**METROPOLITAN DEVELOPMENT COMMISSION
HEARING EXAMINER**

Case Number: 2025-CPL-825 / 2025-CVR-825

Property Address: 7140 and 7142 East Washington Street (approximate addresses)

Request: Approval of a Subdivision Plat to be known as Wawa Shortridge Primary Plat, subdividing 9.4 acres into three lots.

Figure 744.701.05 Connector: Frontage Design & Building Placement & Form

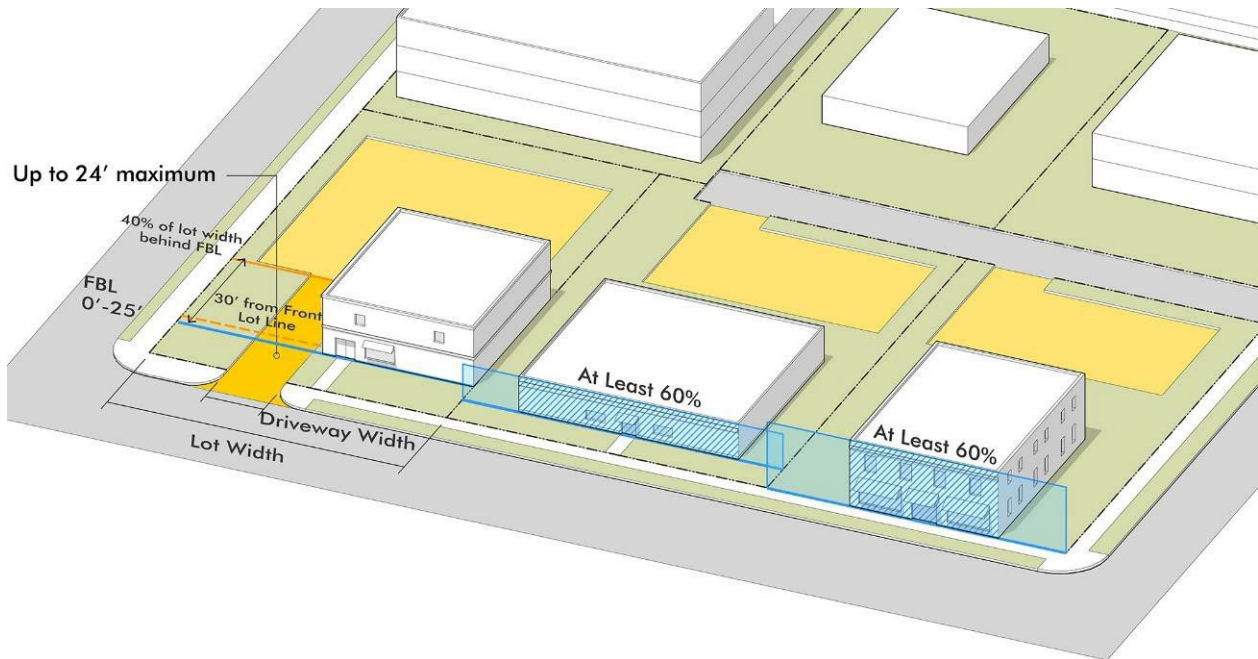
The petitioner is seeking relief from the requirement that surface parking areas be located entirely behind the front building line (FBL), with a minimum 25-foot setback from Washington Street. The submitted site plan depicts a parking area encroaching into the required setback, with certain parking spaces located within the front yard.

According to Table 744-402-1 of the zoning ordinance, the proposed 6,372 square-foot fueling station requires a minimum of 26 off-street parking spaces. The petitioner, however, is providing 62 spaces—more than double the required minimum. Staff finds that this surplus of parking indicates there is no true hardship necessitating the placement of parking within the front yard setback. By simply relocating the eight (8) electric vehicle (EV) charging spaces and two (2) regular spaces currently situated in the setback area to the rear of the site, the petitioner could maintain compliance with parking count requirements while adhering to the TOD Overlay’s form-based development standards.

The intent of these requirements is to maintain a pedestrian-oriented streetscape and prevent vehicular dominance along primary transit corridors. Allowing parking in the front yard would undermine this intent and detract from the urban design character the overlay seeks to establish.

Staff, therefore, **recommends denial** of this variance request as the petitioner has clear and reasonable options for compliance without undue hardship.

2025-CVR-825/ 2025-CPL-825 PLAT

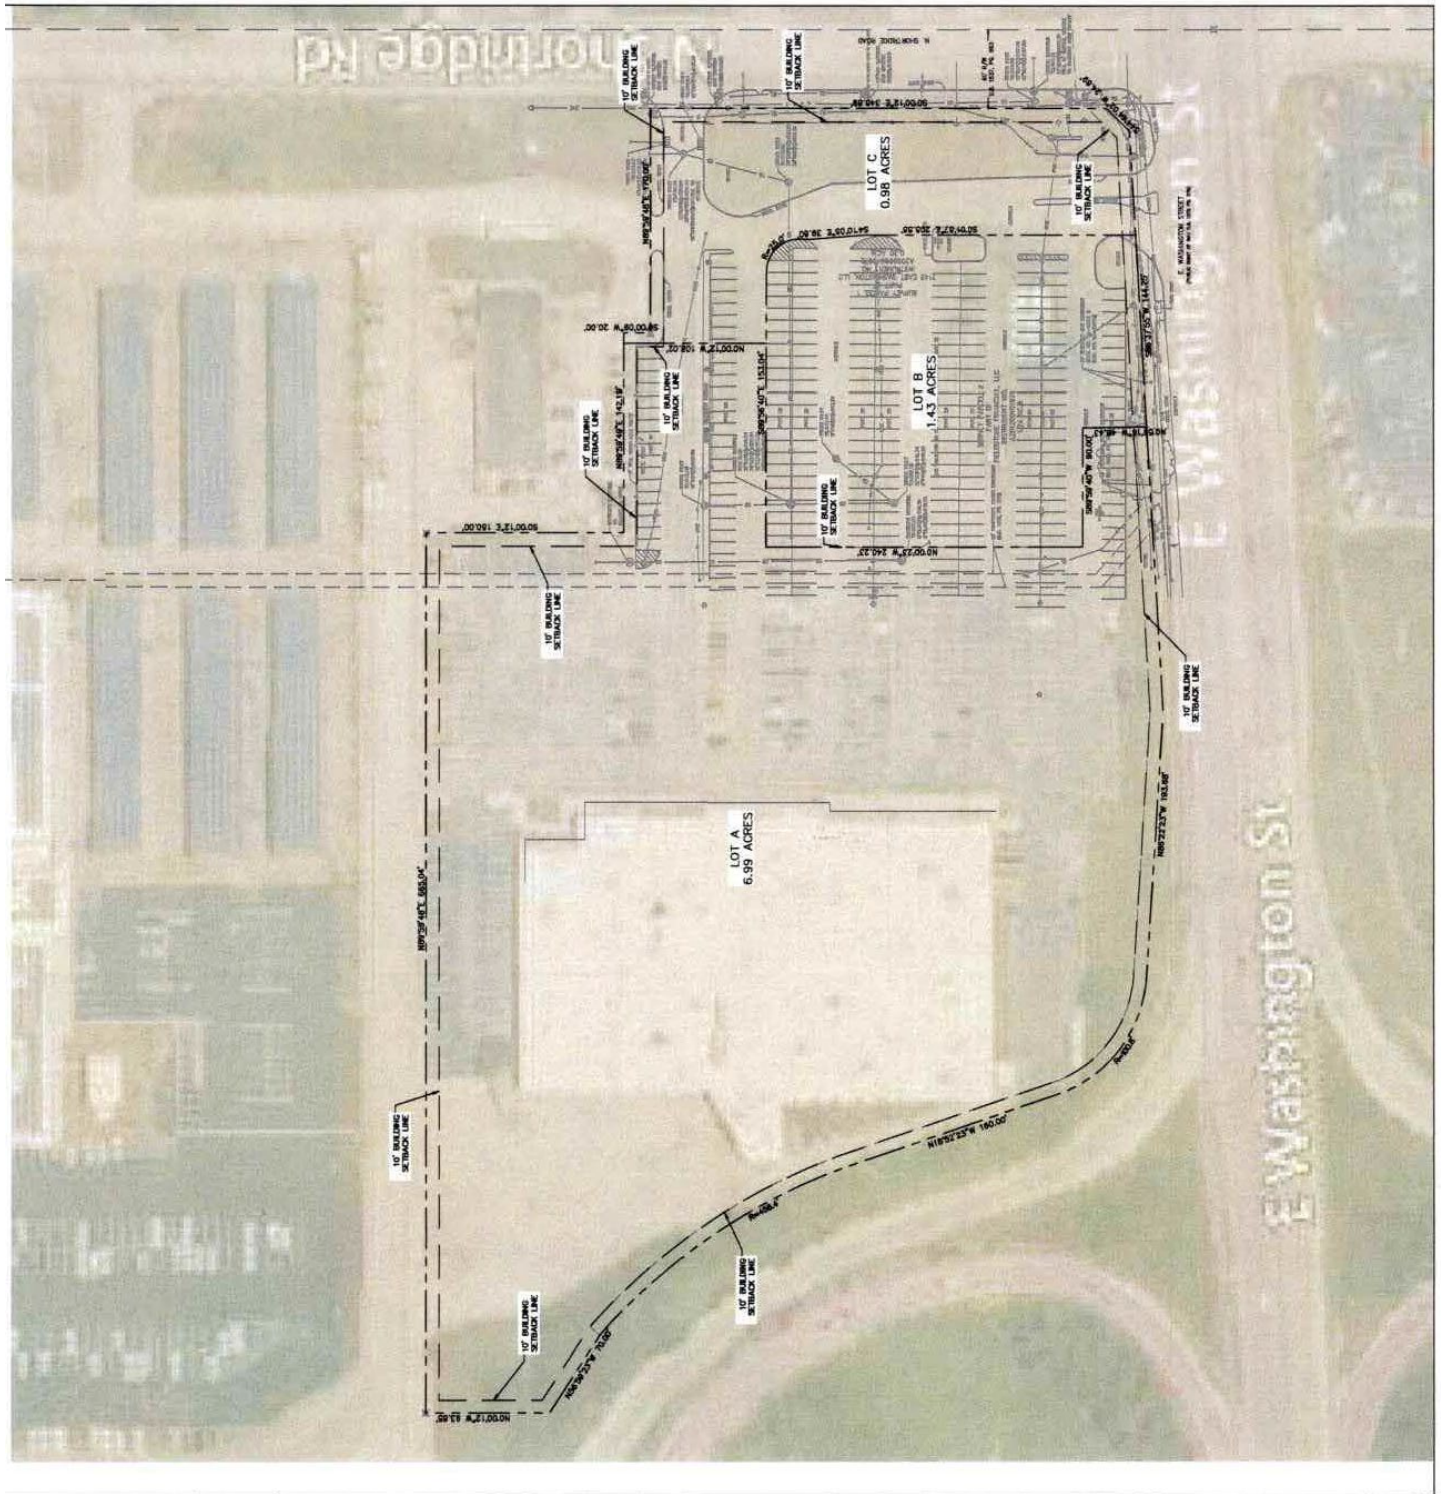
This petition requests the approval of a Subdivision Plat to be known as Wawa Shortridge Primary Plat, subdividing 9.4 acres into three (3) lots.

While the configuration appears to be crafted to technically avoid certain variance triggers, most notably the Front Building Line width requirement, it does so through the introduction of a shared parking easement. This easement appears to serve no functional shared purpose and instead functions primarily

to reduce the frontage calculation of Lot 1. Staff does not support this approach, as it undermines the intent of the TOD Overlay's frontage requirements and circumvents the established form-based development expectations. A design that complies with the spirit and letter of the ordinance—rather than one that relies on artificial lot divisions—is strongly preferred

Sidewalks currently exist along the East Washington Street frontage. However, per Section 722-301. F.2 of the Ordinance, nonresidential and mixed-use developments with more than one (1) primary building must include an unobstructed walkway at least five (5) feet wide connecting those buildings. The current plan does not provide a pedestrian connection between the buildings on Lot 1 and Lot 2.
